Project: IEEE P802.15 Working Group for Wireless Personal Area Networks (WPANs)

Submission Title: Comment Resolution LB-95

Date Submitted: November 4, 2014

Purpose: Comment Resolution for comments collected from LB-95

Resolution: Accepted in principle. Add new figure below to sub clause 31.2.5. with title: “Eye diagram for filtered 4FSK”

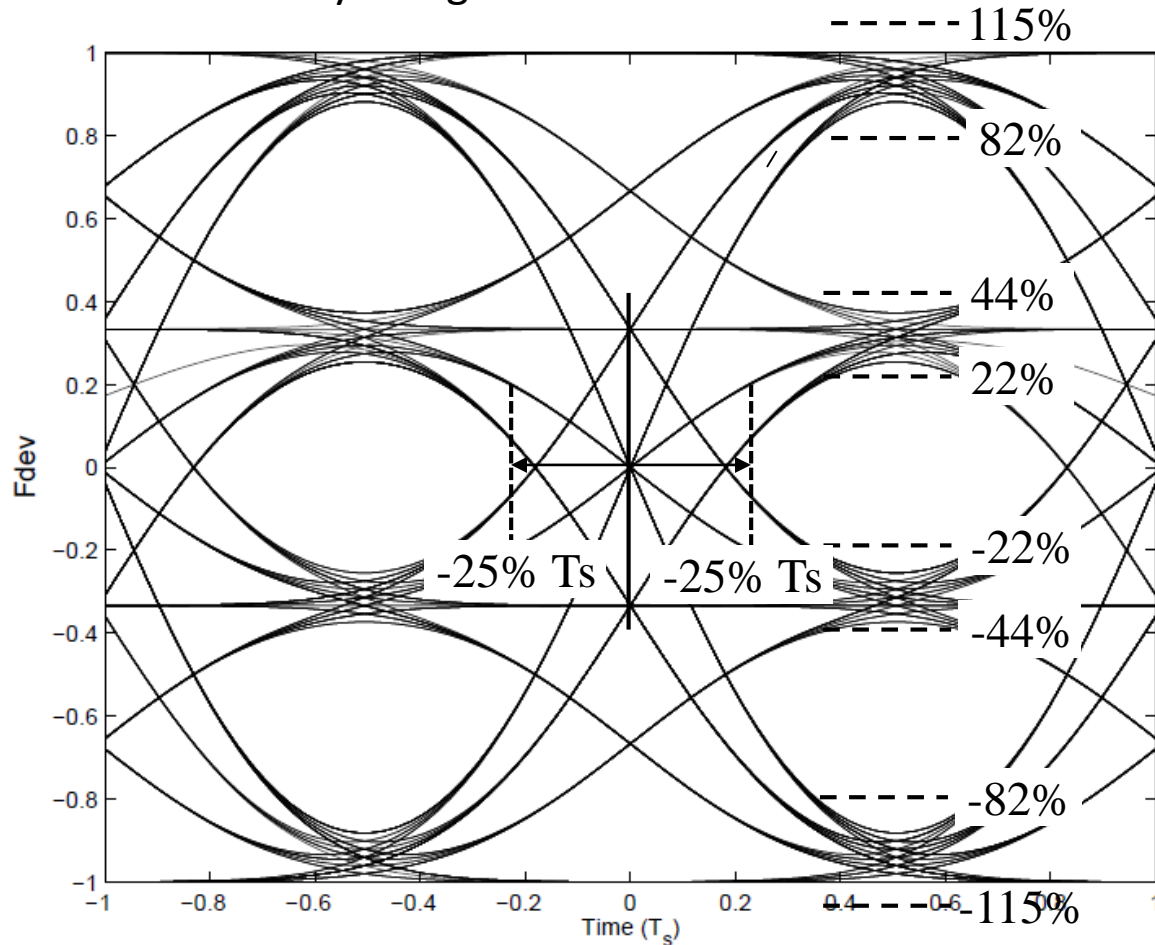
Comment ID: 1174 – slide 1 of 3

Comment: The frequency deviation tolerances are too course. Will degrade the receive sensitivity.

Proposed change: Reduce the deviation tolerance.

Replace sentence "The frequency deviation tolerance shall be as given in 18.1.2.3.1" by "The frequency deviation tolerance for 2-GFSK shall be as given in 18.1.2.3.1. The frequency deviation tolerance for 4-GFSK shall be as given in Figure xx"
